BioRID II C4 Issue for GTR7 TEG meeting September 12, 2019

Issue – C4 Accelerometer Mount

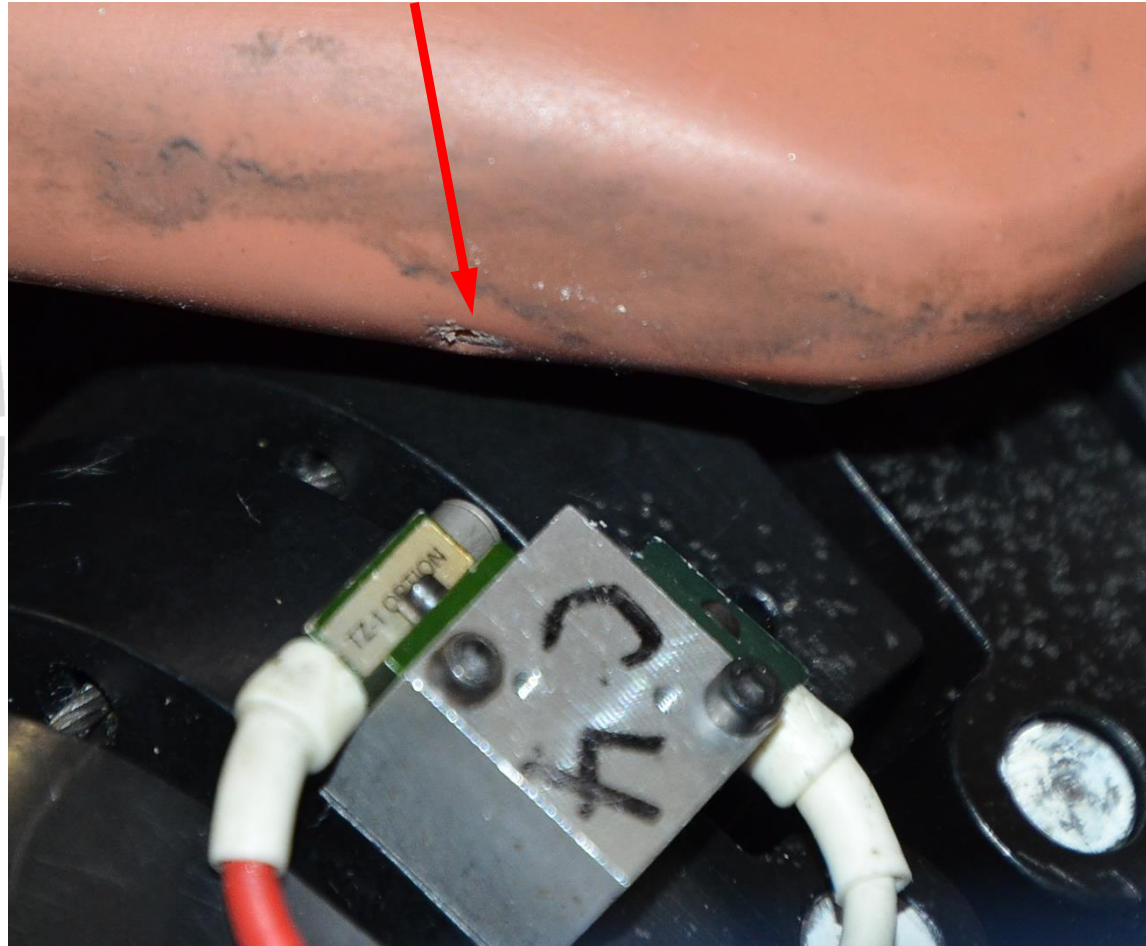
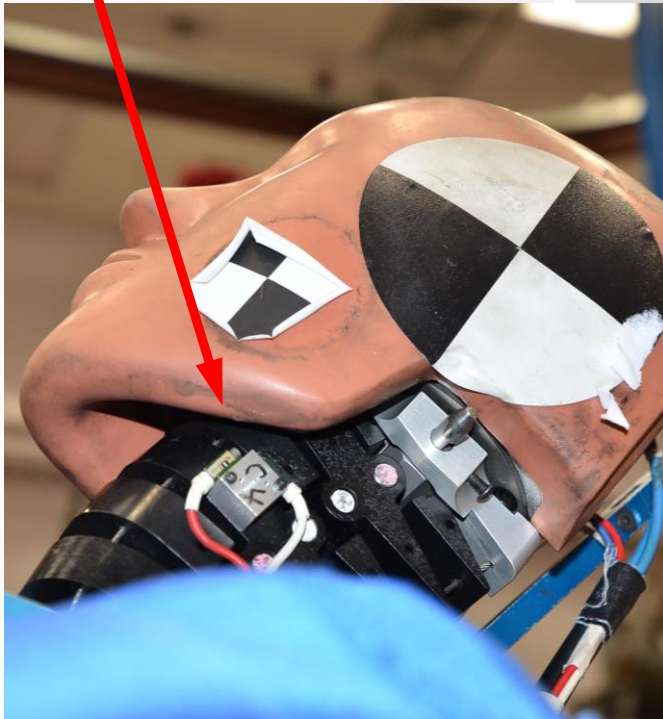
- Sufficient Flexion is possible for the chin to hit the C4 accelerometer or mount on either side of the neck

- We have observed witness marks on multiple customer dummies showing contact has occurred during testing.

Issue – C4 Accelerometer Mount

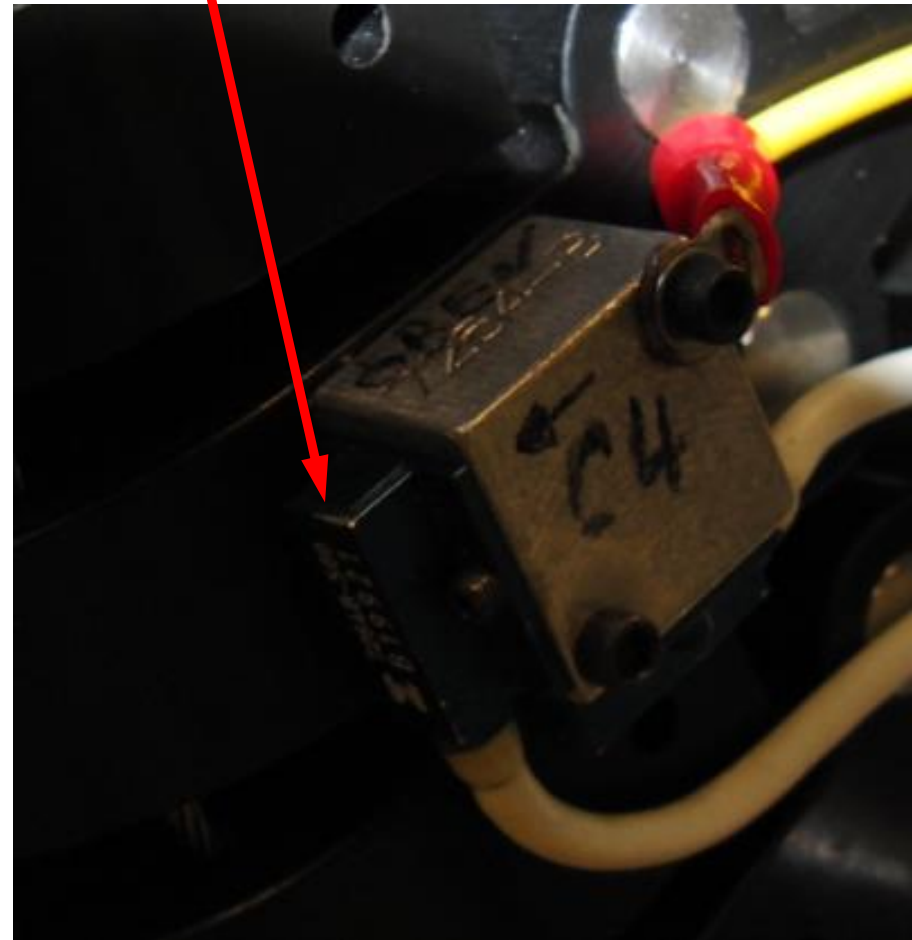
- We have seen
 - damage to skin as in the previous pictures.
 - damage to the aluminum skull
 - Anodize scuffed off of accelerometers (shown here)

- For several years Humanetics has been recommending to remove the C4 accelerometer mount from all testing.

| BioRID II Design Checklist | | ✓ |
|--|---|---|
|  | <p>Remove C4 Accelerometer and mount. This will cause a load path around upper neck load cell and produce erroneous results.</p> | |
